PRELIMINARY OVERALL AREA DEVELOPMENT PLAN for CALLAGHAN 17

Re: Callaghan 17 POADP # 581

P.O.A.D.P REVIEW

Callaghan 17

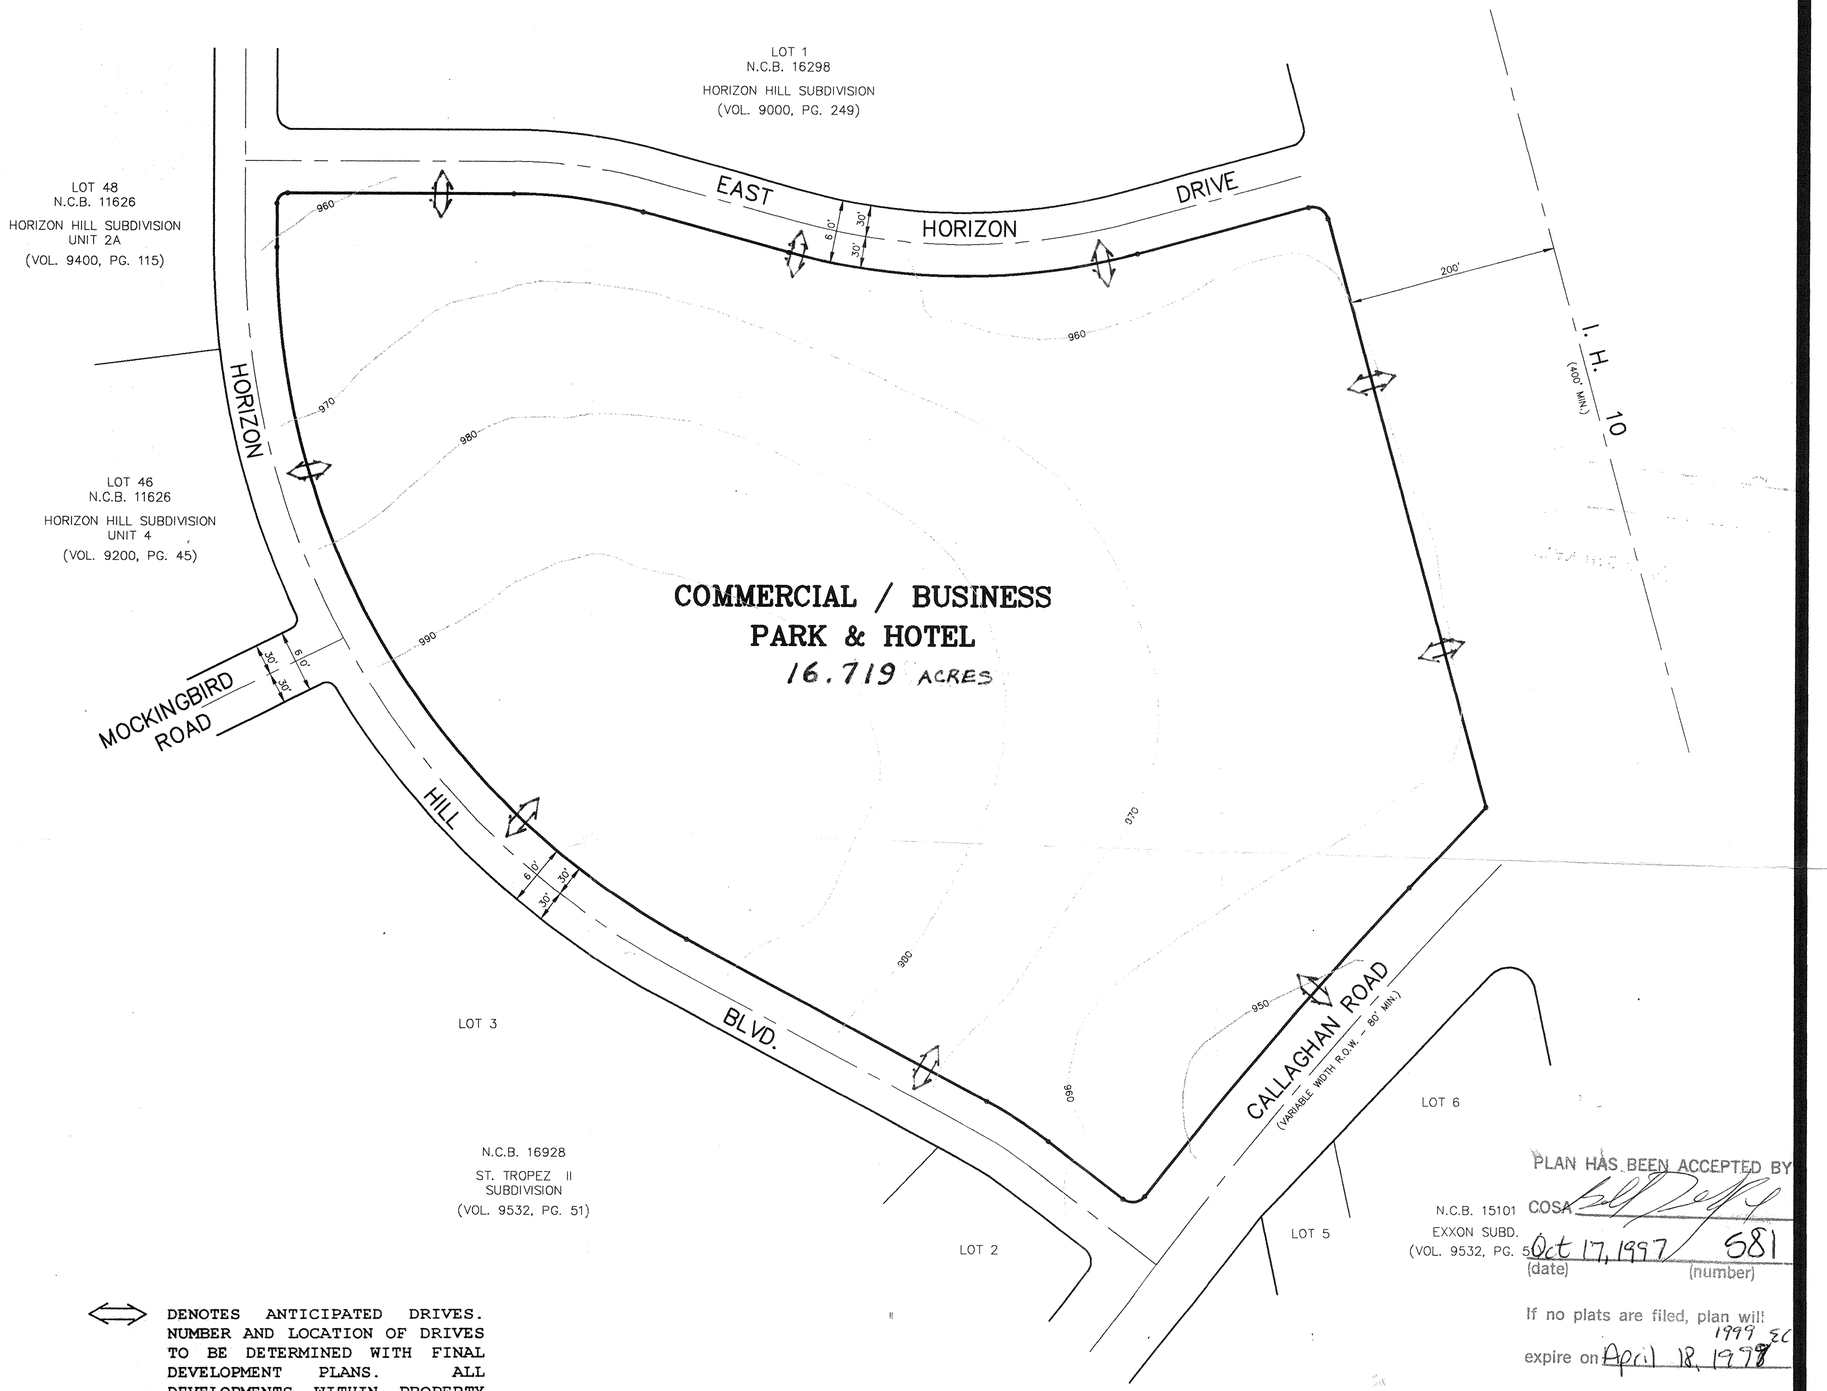
- Access and R.O.W. issues along State facilities will need to be resolved with the Texas Department of Transportation (TXDOT). For additional information about these requirements you can contact TXDOT at 615-5814.
- Based on the topography, a Flood Plain Study and drainage review will probably be required during the platting process.
- Callaghan 17 is a Secondary Type A Major Thoroughfare, and will require a total of 83' of ROW.
- If the proposed development requires the demolition of the large residential structure on the property that activity will first need to be approved by the Historic Preservation and Urban Design Division. For additional information contact Mr. Clint McKenzie at 207-7306.
- This development will need to comply with tree preservation ordinance #85262. For additional information about these requirements you can contact Building Inspections at 207-7102.

Comments: ~~T/A~~ T/A Reqd.
Callaghan (Row 86')

Comments: Drainage easements may be required and will be address during the platting process.

Comments: Drainage easements maybe required and will be address during the platting process.

P.O.A.D.P. Reviewed for:	Comments
Noise Mitigation	For residential development directly adjacent to State ROW, the developer shall be responsible for adequate set-back and/or sound abatement.
R.O.W. Requirements	50' ROW flares will be required at the intersection of the IH 10 frontage road at East Horizon Drive and at Callaghan Road.
Access Limits/Restrictions	This development is eligible for a maximum combined total of two(3) access points along the overall IH 10 frontage. Locations will be as directed by "Regulations For Access Driveways to State Highways".
WPAP Requirements	None

- Callaghan ROW
  43 feet
- Historical issues
- TIA

Callagan Rd. ROW
TIA.
